2.2 Control and Instrument Systems

The information in this section of the reference ABWR DCD, including all subsections, tables, and figures, is incorporated by reference with the following departures.

Figure 2.2.1 Rod Control and Information System Control Interface Diagram

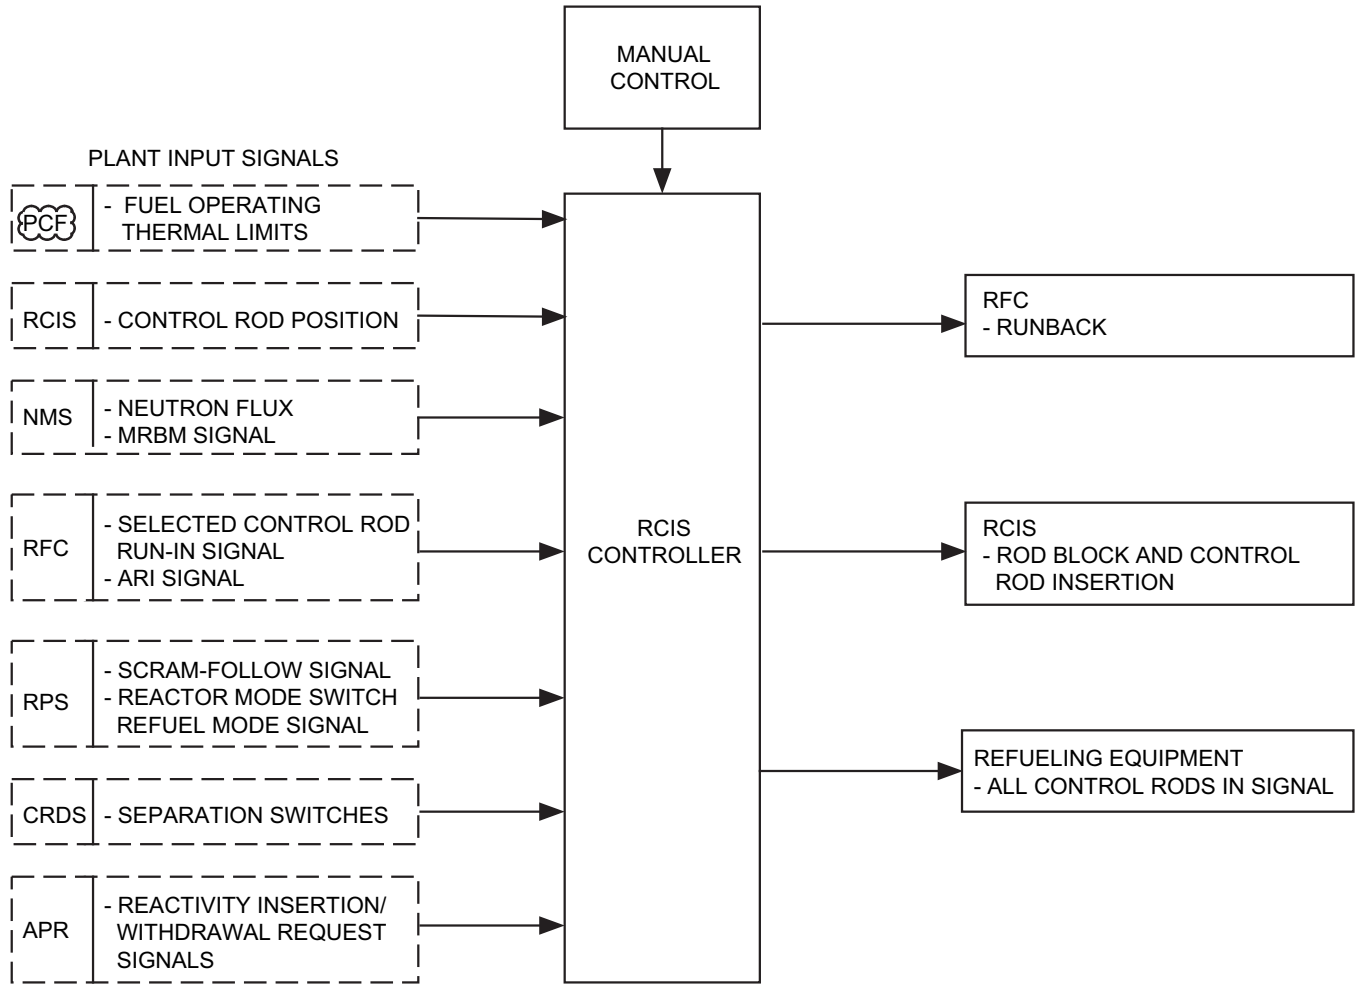
STD DEP T1 3.4-1 (Figure 2.2.1)

NOTE:
1. INTERCONNECTIONS MAY BE FIBER-OPTIC OR METALLIC.

Figure 2.2.5 Neutron Monitoring System

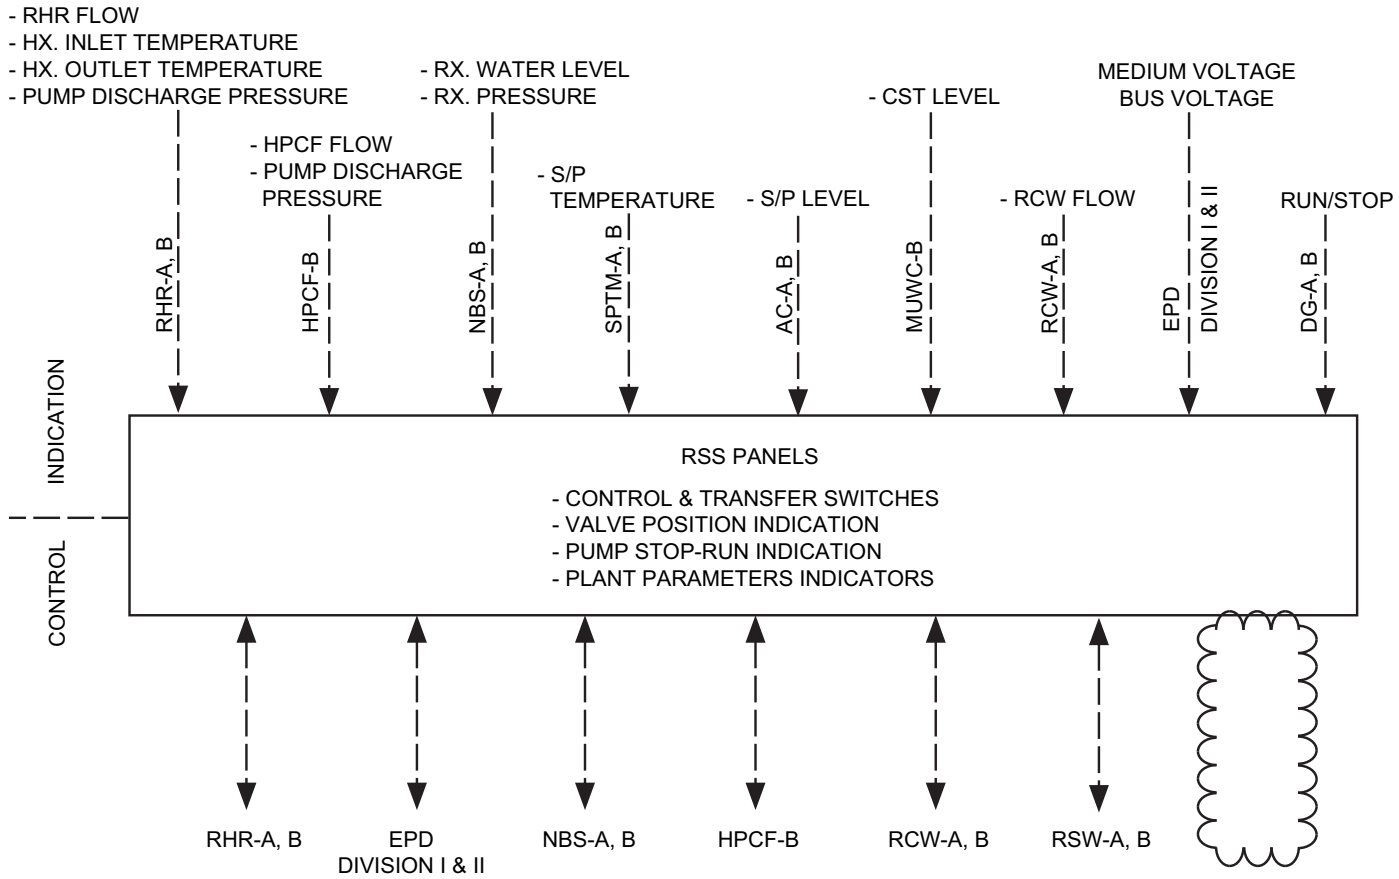
STD DEP T1 3.4-1 (Figure 2.2.5)

1. DIAGRAM REPRESENTS ONE OF FOUR NMS DIVISIONS (MRBM IS A DUAL CHANNEL SYSTEM. THERE IS ONLY ONE IN-CORE INSTRUMENT CALIBRATION SYSTEM).
2. USED FOR RAPID CORE FLOW DECREASE TRIP.
3. SRNM AND APRM ATWS PERMISSIVE SIGNALS TO SSLC.
4. INTERCONNECTIONS MAY BE FIBER-OPTIC OR METALLIC.

Figure 2.2.7b Reactor Protection System

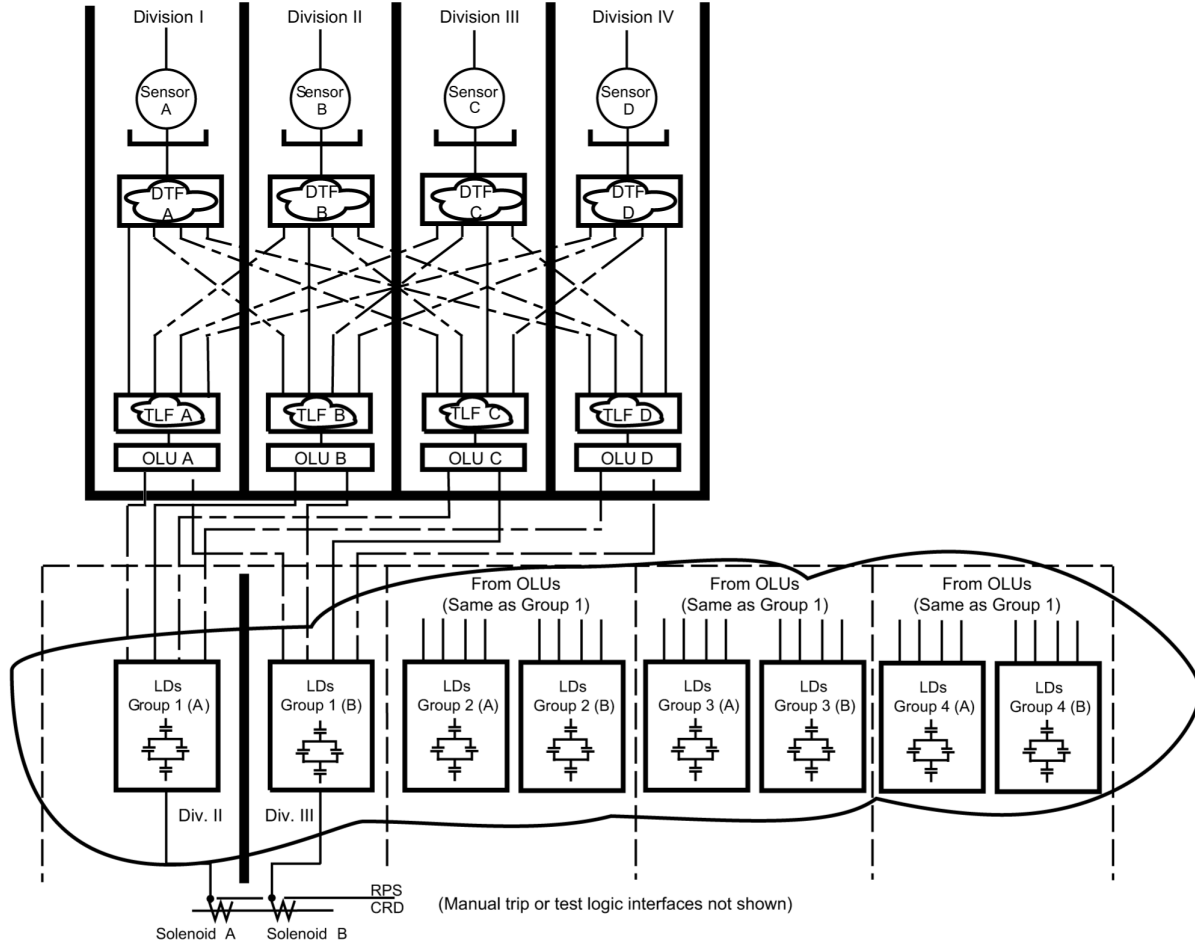
STD DEP T1 3.4-1 (Figure 2.2.7b)

The RPS has four divisions. Figure ~~2.2.6a~~ 2.2.7b shows the RPS divisional aspects and the signal flow paths from sensors to scram pilot valve solenoids. Functions Equipment within an RPS division consists of include sensors (transducers or switches), I/O, ~~multiplexers,~~ data communication, digital trip ~~modules~~ functions (DTM DTF), trip logic unit function (TLU TLF), output logic unit (OLU), and load drivers (LD). The LDs are only in Divisions II and III. The (DTF) and (TLF) are performed in digital configurable logic devices. The data communication functions are described in Section 2.7.5.

The RPS consists of logic and circuitry for initiation of both automatic and manual scrams. The automatic scram function is ~~comprised of~~ accomplished redundantly in four independent divisions of sensor instrument channels, hardware/software based logic and logic processing, and two independent divisions of actuating devices. Automatic scram is initiated whenever a scram condition is detected by two or more automatic divisions of RPS logic. ~~For automatic scram, the sensor input signals to the RPS originate either from the RPS's own sensors or other systems' sensors. For determination of the existence of an automatic scram condition, within each automatic scram channel division of the RPS, the DTM DTF of a given RPS channel division compares the monitored process variable with the a stored setpoint stored in its memory and issues a trip signal if the monitored process variable exceeds the setpoint. The DTM DTF then sends the trip signal to the TLU TLF of its own channel division and the TLU TLFs of the other three channels divisions of RPS, where two out of four voting is performed (see Figure 2.2.6a). The TLF in each division performs an independent two-out-of-four vote on each RPS DTF input.~~

~~In the case of high suppression pool average temperature trip and inboard/outboard MSIV closure signals, the SPTM module of SSLC and NBS provide their divisional trip signals directly to the corresponding divisional RPS DTM. However, In the case of the NMS, the four channels divisions of the NMS each provide their trip signals to each RPS divisional TLU TLF. A list of conditions that can cause automatic reactor scram is provided below. The name of the system that provides the sensor input signal or the trip signal is shown in brackets.~~

- (3) NMS Trips [~~Discrete trip signals to RPS TLUs~~NMS]

- (7) Main Steamline Isolation [~~NBS discrete signals to RPS DTMs~~]
- (9) High Suppression Pool Average Temperature [~~SPTM Module of SSLC trip signals to RPS DTMs~~]

The ~~TLU~~ TLFs provide their trip signals to their divisional OLUs which ~~are used to~~ control the solid-state LDs that control the Class 1E AC power to the scram solenoids, and relays that control DC power to back-up scram valves. For automatic scram initiation, the ~~TLU~~ TLF trip signals cause the LDs to interrupt Class 1E AC power to the scram solenoids (fail-safe logic), cause the back-up scram relays to supply DC power to back-up scram solenoids, and provide scram follow signals to the RCIS. Each division of RPS controls eight LDs. The LDs are arranged to switch AC power to the scram solenoids in a two-out-of-four ~~format arrangement~~. That is, reactor scram will occur only if two or more divisions of the RPS provide trip signals to their associated LDs and both scram solenoids are de-energized.
